Item ID: D206-667-147TRN

Item Name: Crosstube Assembly, Mid Fwd

DART AEROSPACE LTD	Work Order:	161183
Description: Crosstube Assembly, Mid Fwd	Part Number:	D206-667-147
Inspection Dwg: D206-667-147 Rev: A		Page 1 of 2

DRAWING NO. D206-667-147	TITLE CROSSTUBE ASS'Y (206L MID FWD)	REV. A	DART AEROSPACE LTD ENGINEERING ORDER		D.E.O. NO. D206-667-147-A-1	SHEET NO. SHEET 1 OF 1	SCALE NTS
DRAWN <i>92</i>	CHECKED <i>ADS</i>	MFG. APPR. <i>JD</i>	APPROVED <i>MD</i>		DE APPR. <i>MD</i>		
DATE 11.07.15	DATE 11.07.20	DATE 11.07.21	DATE 11.07.21		DATE 11.07.21

DETAIL P
BONDING STRAP INSTALLATION 2 PL

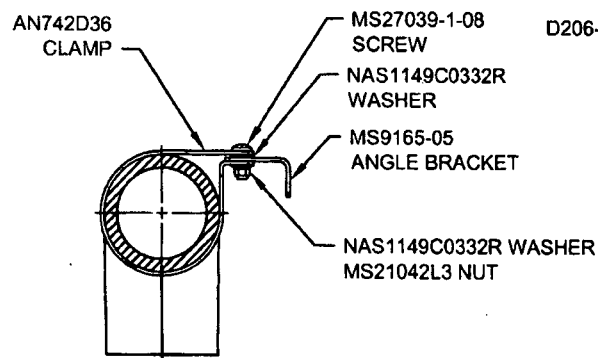
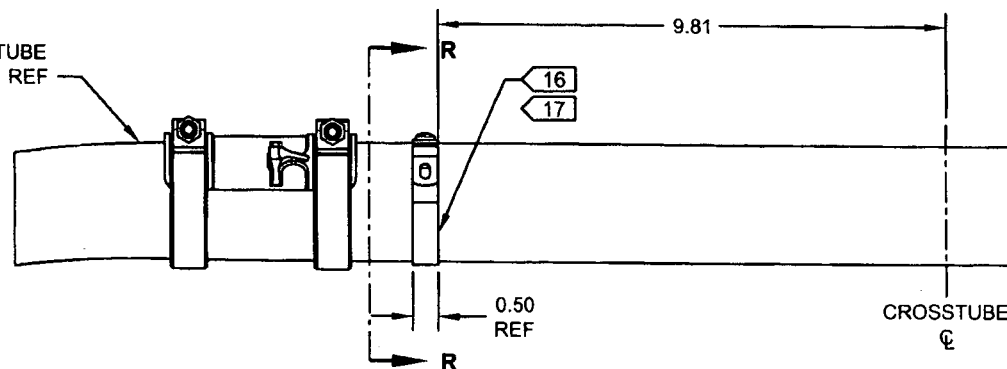
ADD ELECTRICAL GROUNDING STRAP

- 16) MASK AREA UNDER CLAMP PRIOR TO PAINTING
- 17) SEAL EDGES WHERE AN742D36 CLAMP MEETS WITH THE CROSSTUBE USING SIKAFLEX-241/-291 OR MIL-S-8802 CLASS B2 OR PROSEAL 890 SEALANT
- 18) PERFORM RESISTANCE CHECK TO ENSURE MAX RESISTANCE IS 10 MILLIOHMS

ITEM	QTY -147	PART NUMBER	DESCRIPTION
1	X	D206-667-147	CROSSTUBE ASSEMBLY (206L MID FWD)
10	2	AN742D36	CLAMP
11	2	MS9165-05	ANGLE BRACKET
12	2	MS21042L3	NUT (OR MS21042-3)
13	2	MS27039-1-08	SCREW
14	4	NAS1149C0332R	WASHER (OR AN960C10L)
